**ZONING AMENDMENT,
& SUBDIVISION STAFF REPORT****Date: September 4, 2008****APPLICANT NAME**

H.S. Norden Place Subdivision, Lot 2 Amended

LOCATION1016 Hillcrest Road
(West side of Hillcrest Road, 470'± South of Wall Street)**CITY COUNCIL
DISTRICT**

Subdivision approval to combine two legal lots of record into one lot and Rezoning from B-2, Neighborhood Business District, and B-3, Community Business District, to B-3, Community Business District, to eliminate split zoning in a proposed commercial subdivision, and to remove a condition of a previous rezoning to allow visitation and a crematorium at an existing funeral home.

SITE PLAN

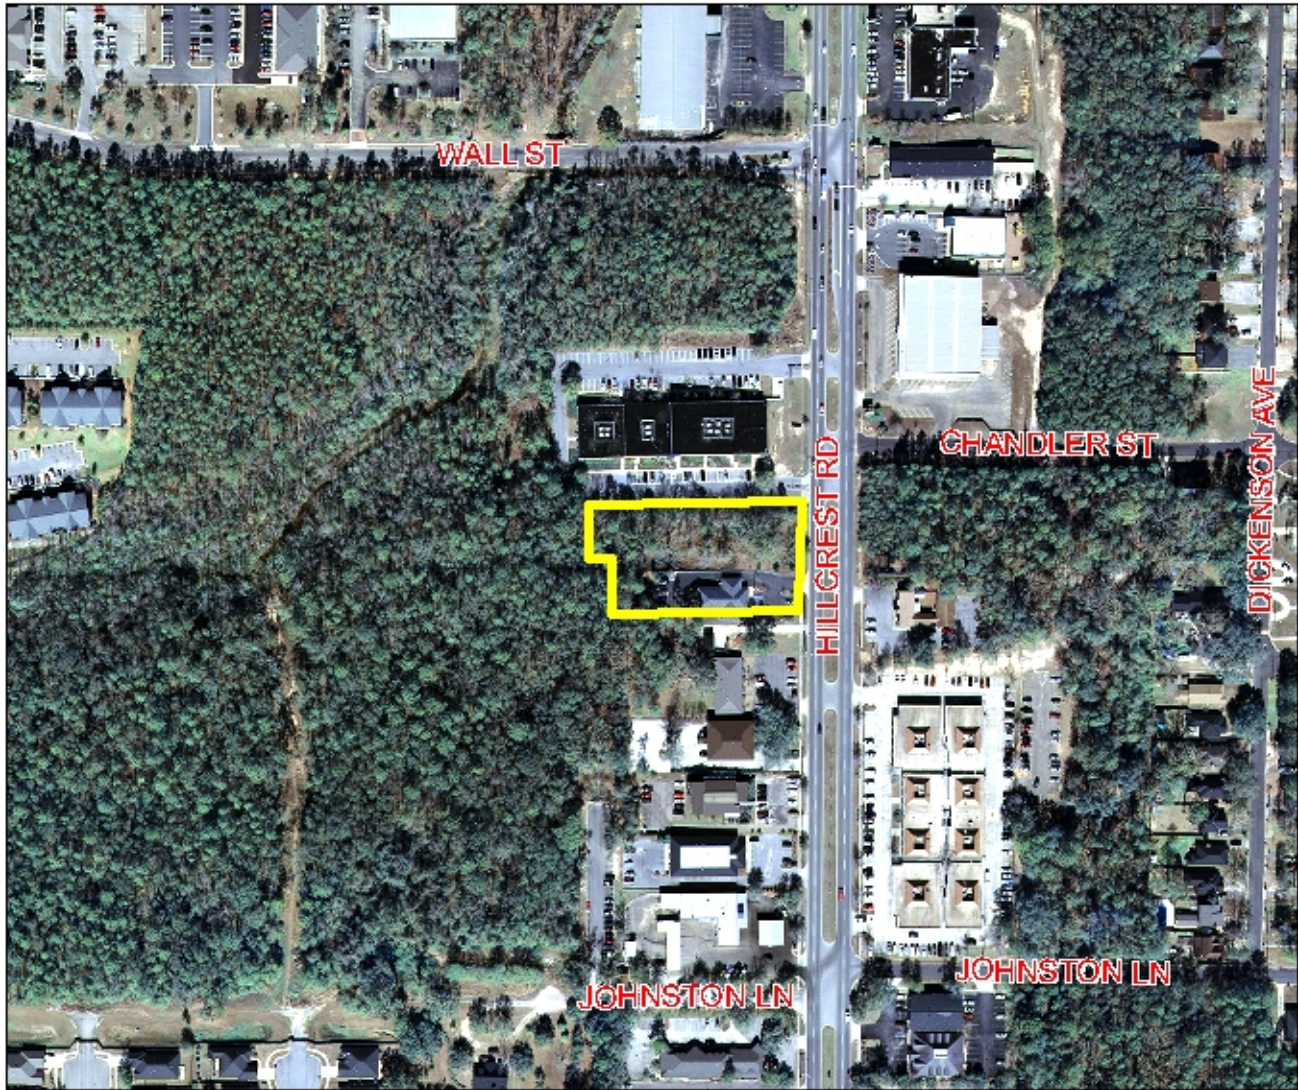
There is no depiction of a buffer where the site abuts residentially zoned property to the West. One condition of the previous rezoning was that the wooded area on the Western portion of the site be left undisturbed as a natural buffer from the adjacent residentially zoned property. However, as illustrated on the site plan, a portion of this natural buffer is to be removed to accommodate storm-water detention. Therefore, while a privacy fence was not necessary in the past, one will be required, if approved as requested.

The site plan illustrates the proposed 400 square foot addition to the existing building for a crematorium, along with 42 parking spaces. However, while there appears to be adequate parking, no information is provided regarding the square footage of the existing building. The applicant should revise the site plan to provide this information, specifying the ratio of office to visitation use. Office use requires one parking space for every 300 square feet of gross floor area, whereas the visitation aspect will require one space for every four seats, based upon maximum Building Code seating capacity.

As already mentioned, the applicant is proposing two one-way curb cuts. There are two issues with this proposal:

- 1) typically, sites with less than 200' of road frontage are limited to one curb cut (this site has approximately 166' of frontage); and
- 2) the width of the proposed cuts, along with the design of the proposed parking lot, do not support one-way circulation. Typical one-way drives are between 12 and 16' in width,

rather than 24' as proposed, and parking lots are designed (angled and painted with arrows) in such a way as to discourage two-way traffic.

It should be noted that the site plan, as proposed, does not meet the minimum requirements of Zoning Ordinance with regard to trees/landscaping. Of the 1.15 acres (50,094 square feet), 12 percent (6,011 square feet) shall be landscaped; 60 percent (3,607 square feet) of this requirement shall be located on the building site between the street line and the building wall facing the street. The front setback shall have one over-story tree for every 30' of road frontage. There should also be a tree for every 30' of perimeter (no more than one half of the perimeter trees may be under-story). Furthermore, any existing trees for which the applicant wishes to receive credit shall be labeled with type and size on the site plan.

- 1) Completion of the Subdivision process;
- 2) Provision of a 6' high privacy fence, in compliance with Section 64-4.D. of the Zoning Ordinance, where the site abuts residentially zoned property to the West;
- 3) Revision of the site plan to comply with the requirements of the Zoning Ordinance;
- 4) Compliance with Traffic Engineering comments (*Both drive entrances should be narrowed to between fourteen and sixteen to prevent two-way traffic*), or the elimination of the one-way designation of the curb cuts;
- 5) Approval of all applicable federal, state and local agencies is required for endangered, threatened or otherwise protected species, if any, prior to the issuance of any permits or land disturbance activities; and
- 6) Full compliance with all other municipal codes and ordinances.

- 1) Placement of a note on the final plat stating that the site is limited to two curb-cuts onto Hillcrest Road, with the size, design and location of all curb-cuts to be approved by Traffic Engineering and in conformance with AASHTO standards;
